TO: Mercedes-Benz Dealer Principals, General Managers,	FROM: Gregory Gunther, Senior Manager, Vehicle	
Sales Managers, Service Managers, Parts Managers	Compliance and Analysis, Engineering Services	
RE: Service Campaign Launch Notification		
Check Front Left and Right Wheel Well	DATE: March 1, 2024	
Reinforcement		
MY22-23 EQS (297 platform)

Campaign No. 2023090009, March 2024

Inspect Front Left and Right Wheel Well Reinforcement

Figure 1, (Left wheel well)

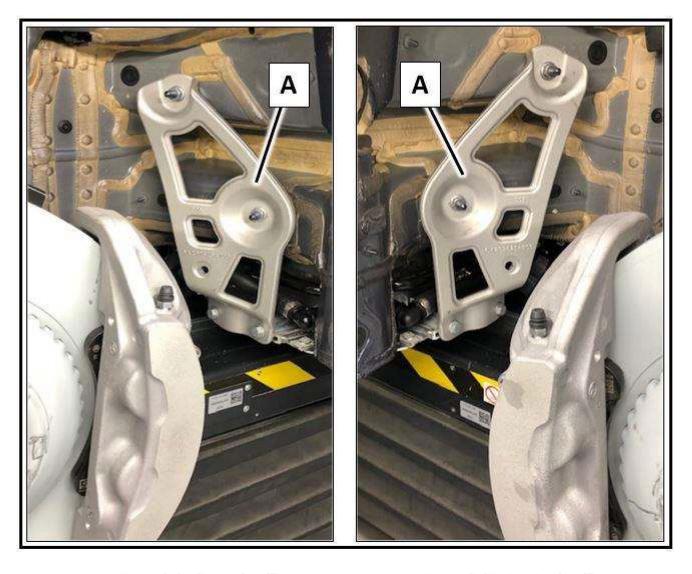
- 1. Lift vehicle on vehicle lift.
 - i For basic data, see AR00.60-P-1006A.
- 2. Remove center section of lower engine compartment lining.
 - i For basic data, see AR61.20-P-1105EQS.
- 3. Visual check if reinforcement is installed in both left and right front wheel wells (A, Figures 1 and 2).
 - a. Reinforcement on wheel well (A) not present: Carry out work procedure.
 - b. Reinforcement on wheel well (A) present: End measure.

1.	For basic data, see AR40.10-P-1102A.
2.	Remove rear section of front fender liner from affected side. i For basic data, see AR88.10-P-1301EQS
3.	Retrofit reinforcement on wheel well as shown (A, Figures 1 and 2) on the affected side(s). I Tighten screw with 30 Nm torque. I Tighten nut with 30 Nm torque.
4	Assemble in reverse order
